Work Order ID 99736

Item ID: D4456-5 Accept *N9000040100* Setup Start *NS1*
 Revision ID: Stop *NS2*
 Item Name: Center Raingutter
 Start Date: 4/11/13 Start Qty: 6.00 *B* *9*
 Required Date: 4/11/13 Req'd Qty: 6.00 *B*
 Reference: Cust Item ID:
 Customer:

WORK ORDER NON-CONFORMANCE / UPDATE

D4456-5 CENTER RAINGUTTER

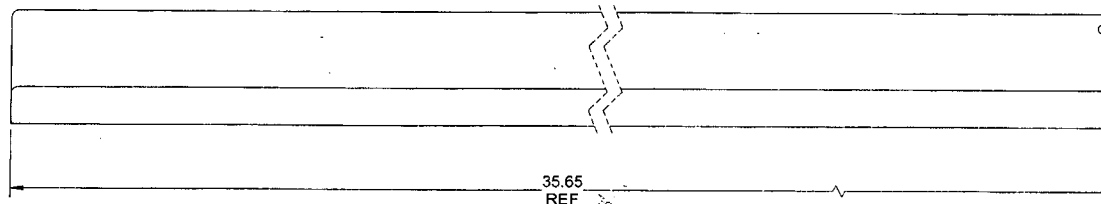
| Root Cause | Date | Step | Qty | Description or Non-conformance | Initial Chief Eng | Action Description | Sign & Date | Verification | QC Inspector |
|---|----------|------|-----|--------------------------------|-------------------|--------------------|-------------|--------------|-----------------|
| Setup <input type="checkbox"/> | 13/10/11 | 130 | 7 | 21 parts are too wavy | DAS 16 9-89 | Scrap & destroy | SJ | DAS 27 9-89 | DAS 16 9-89 |
| Other <input type="checkbox"/> | | | | 2. Poor tooling | Q57042 13/10/15 | W3 replace | 13/10/11 | 13.10.15 | Q57042 13/10/15 |

D4456-5F CENTER RAINGUTTER FLAT PATTERN

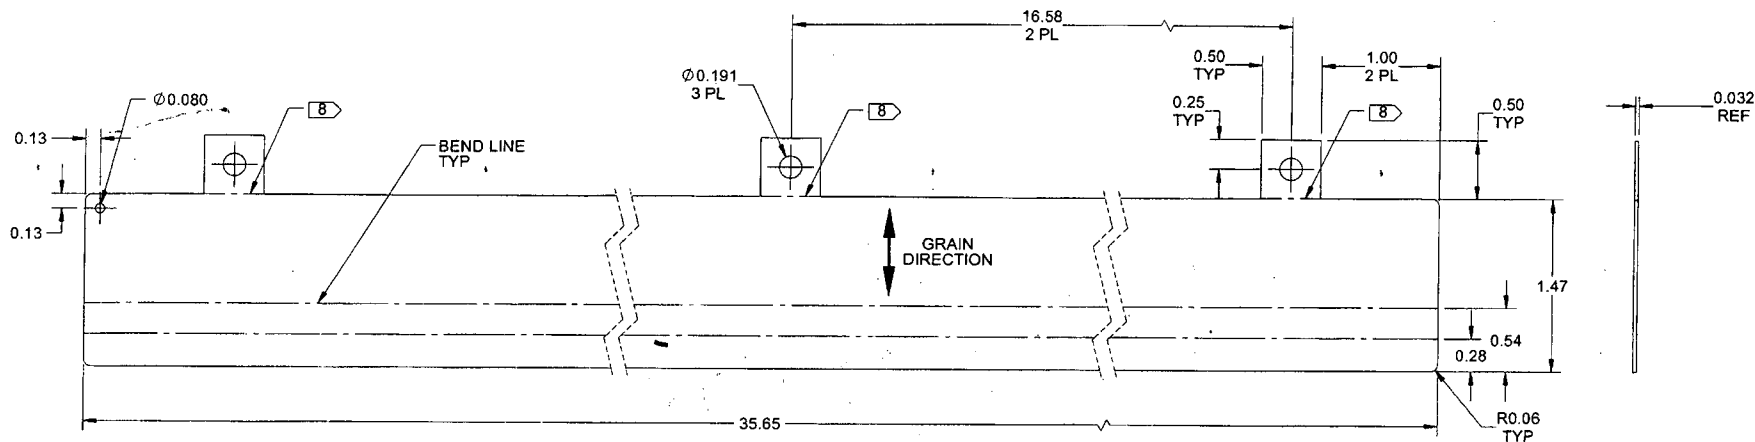
| Root Cause | Date | Step | Qty | Description of work order update or Non-conformance | Initial Chief Eng | Action Description | Sign & Date | Verification | QC Inspector |
|--|---------|------|-----|---|-------------------|--|-----------------|--------------|-----------------------------------|
| Doc/Data <input type="checkbox"/> | 9/24/13 | 100 | 9 | 0.080" HOLES ARE 0.093 - 0.095 0.191" HOLES ARE 0.204 - 0.206. RC. Operator Error | A.P. 9/24/13 | 0.080 HOLES ARE FOR FINISHING ∴ ACCEPTABLE 0.191 HOLES ARE REMOVED ∴ ACCEPTABLE | A.P. 9/24/13 | 27 13924 | DAS 16 9-89 13/10/15 |
